ADDENDUM NO. 1

March 19, 2025

School District of Haverford Township | Coopertown Elementary School Renovations & Additions
CRA Project No. 3758

A4.5

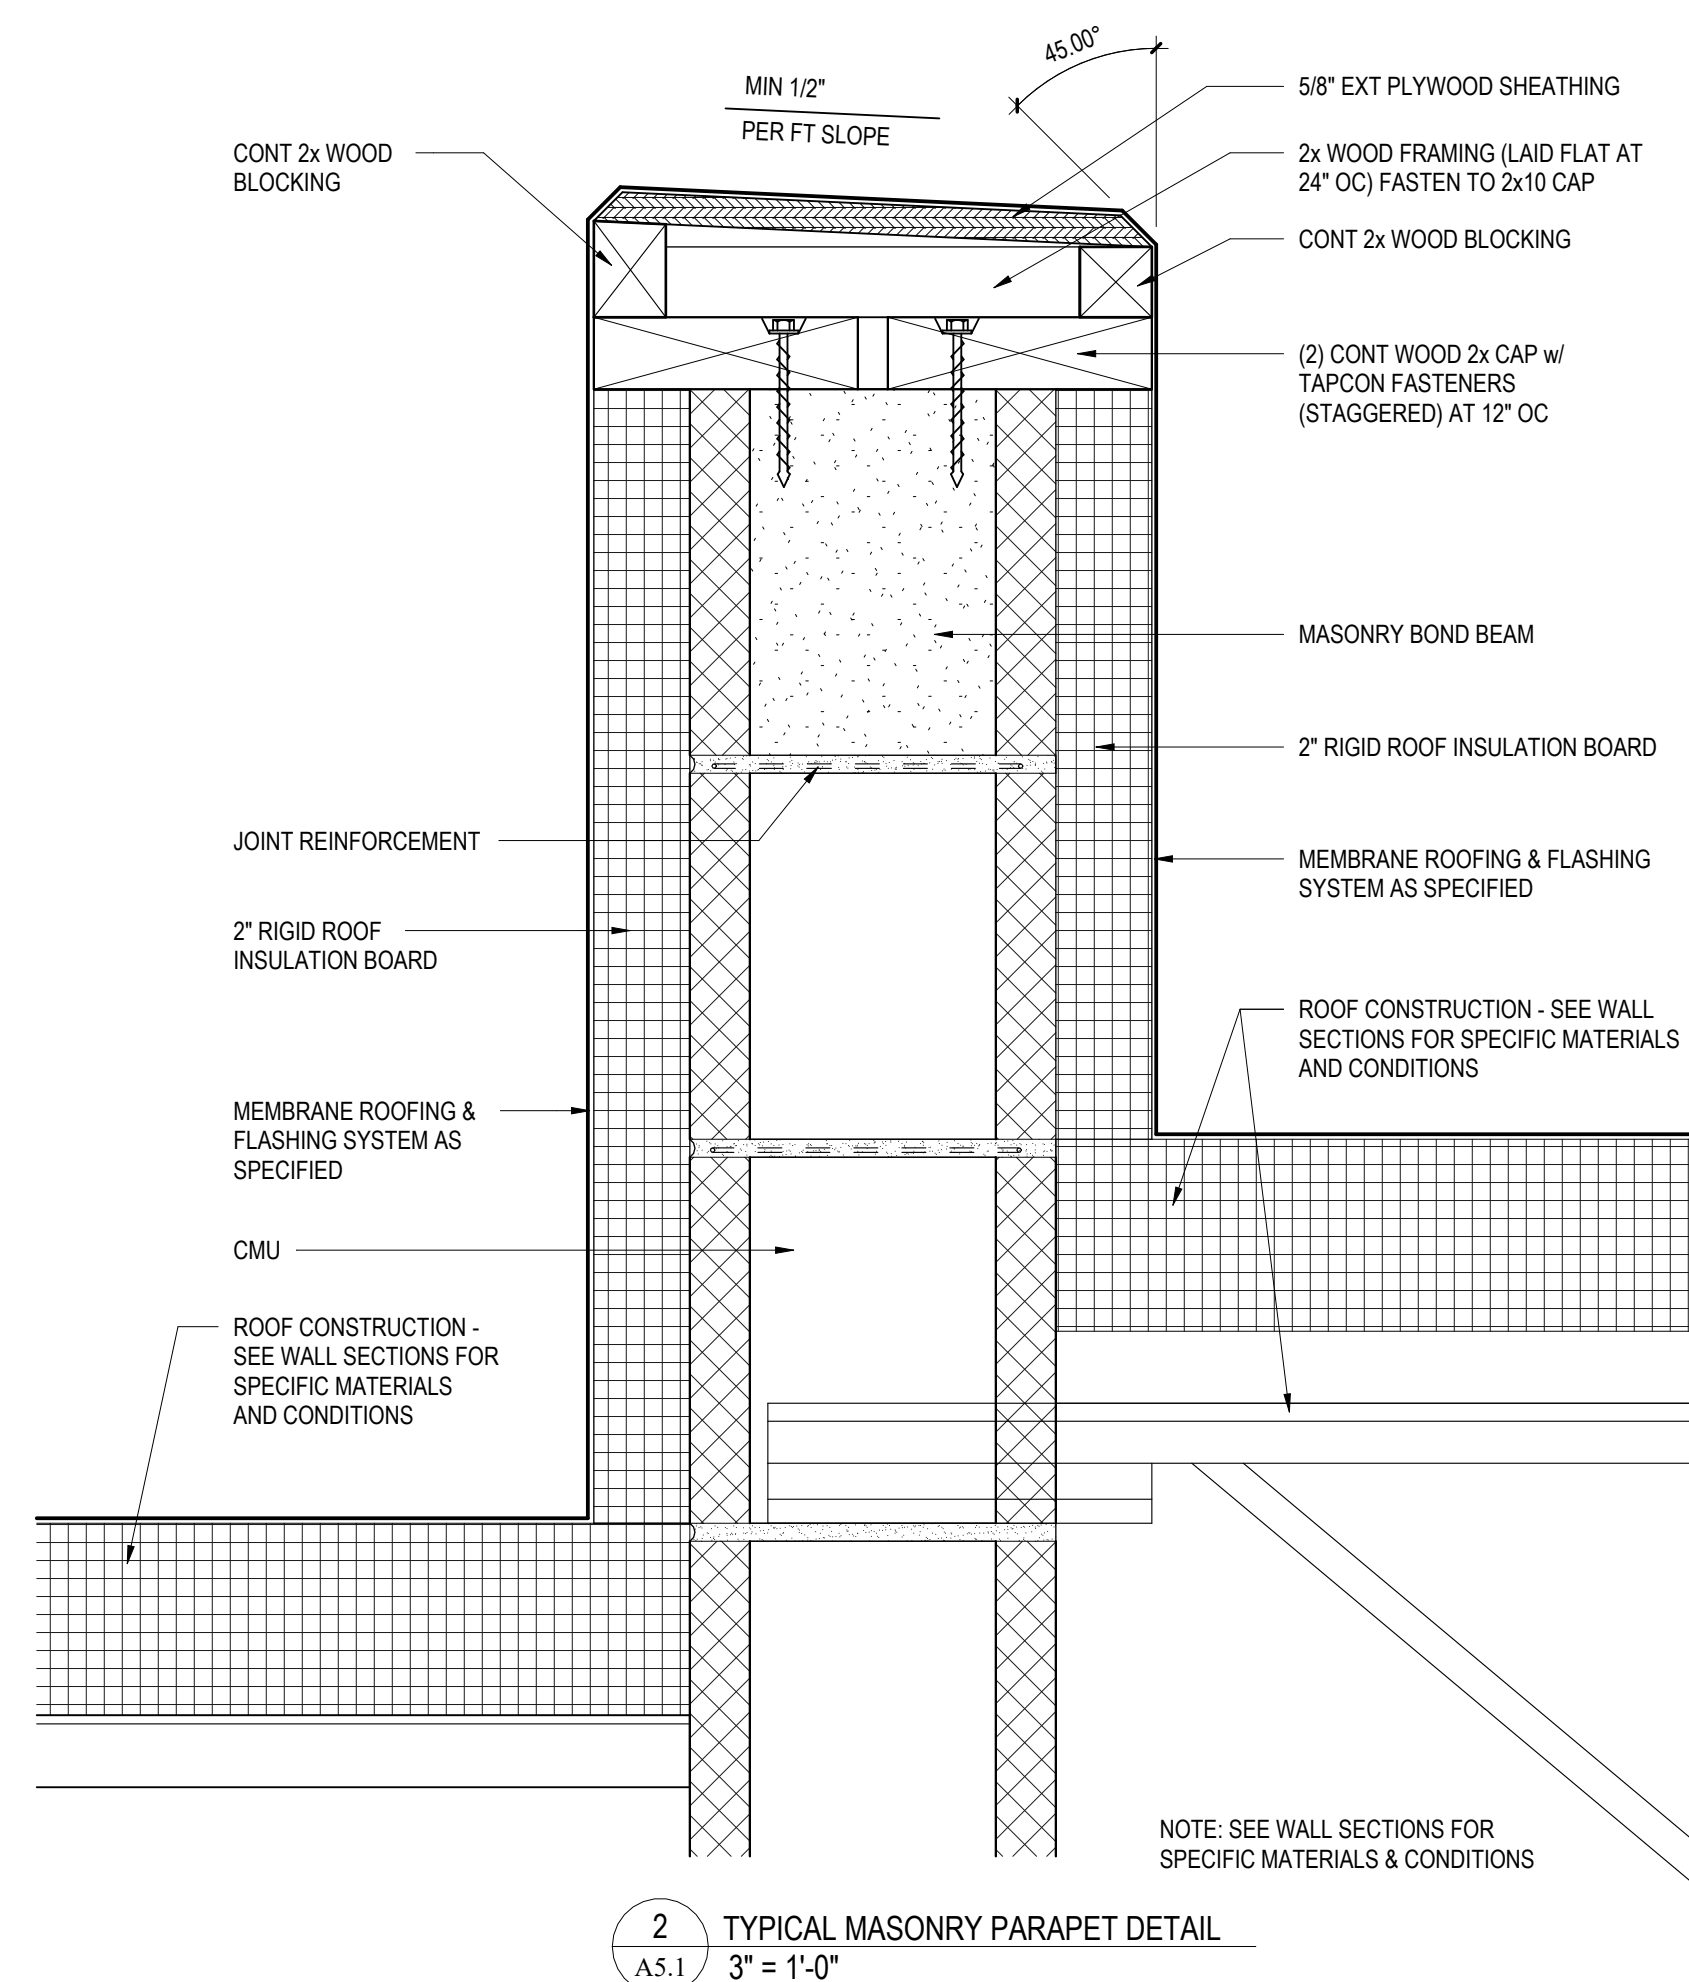
1. ADD – note to boulders and stone bed
2. REMOVE – bench at front entrance

A5.3

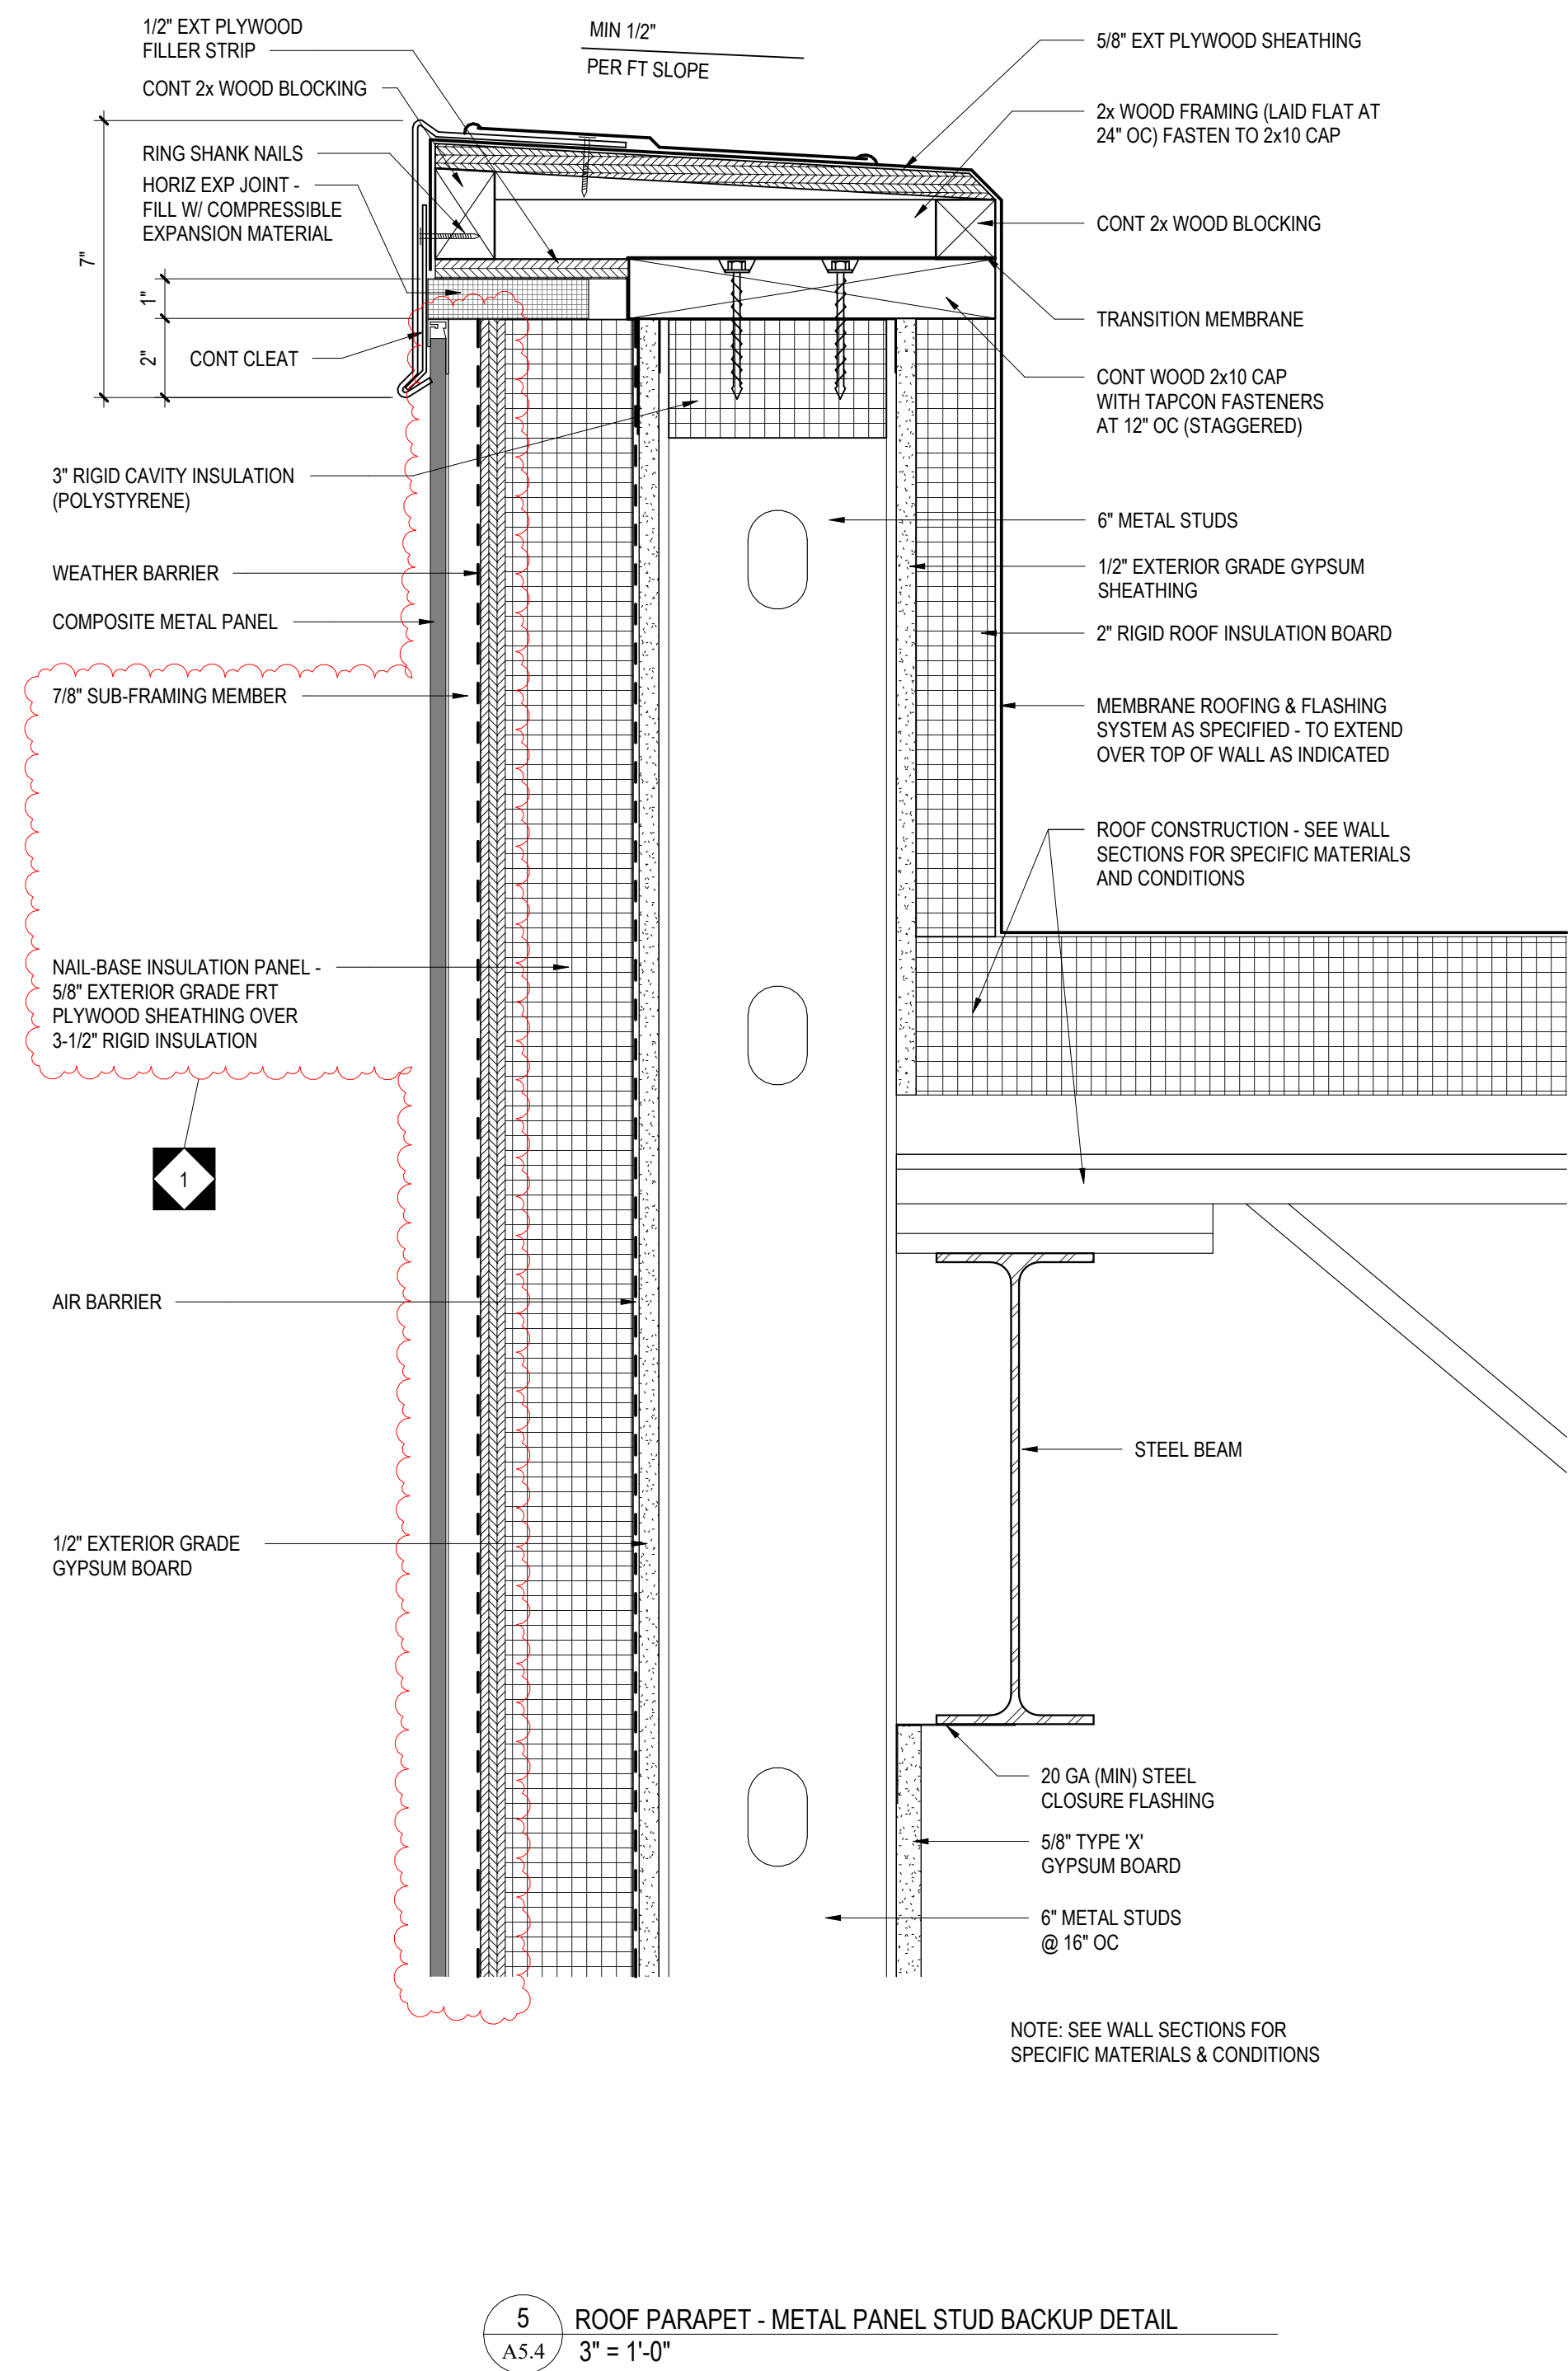
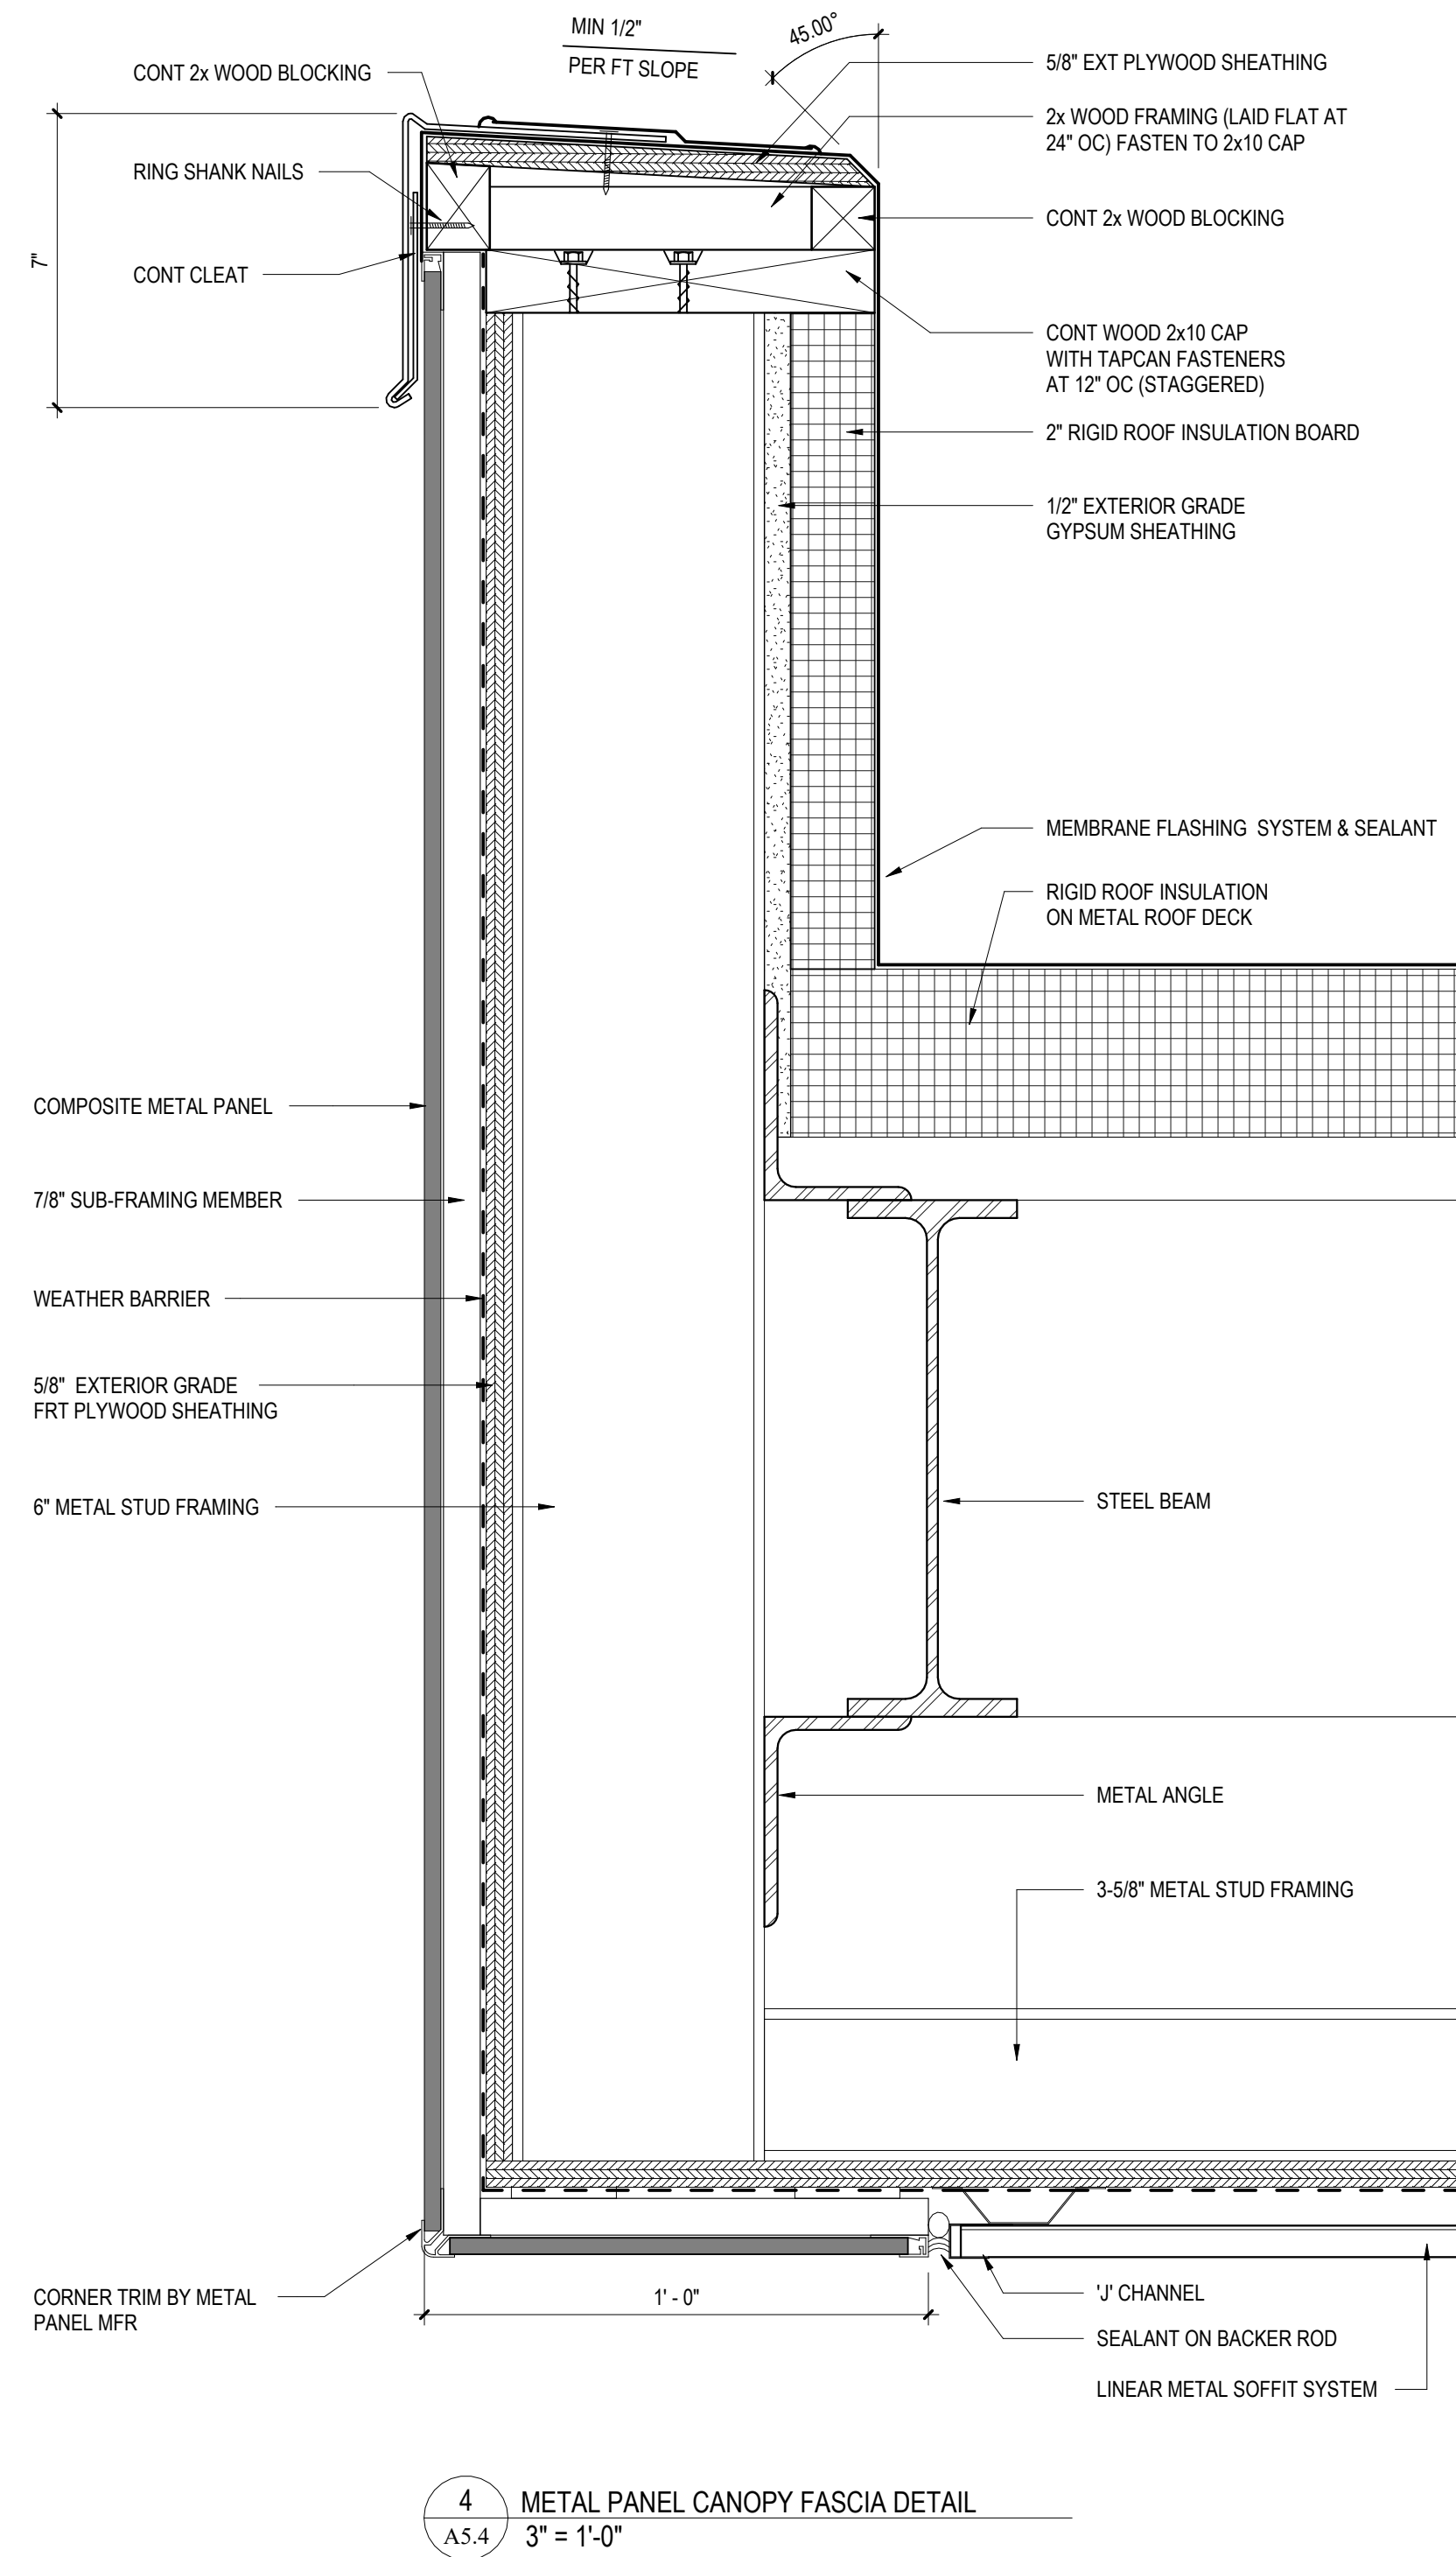
1. DELETE - Detail 3/A5.3
2. 1/A5.3
 - a. REVISE - Standing seam interior gutter detail changed from stainless steel liner to 60 mil EPDM liner
3. 2/A5.3
 - a. REVISE - Nailbase changed to 3-½" insulation and sub-framing depth updated to be 2" matching annotation
4. REVISE - Annotation inconsistencies clarified
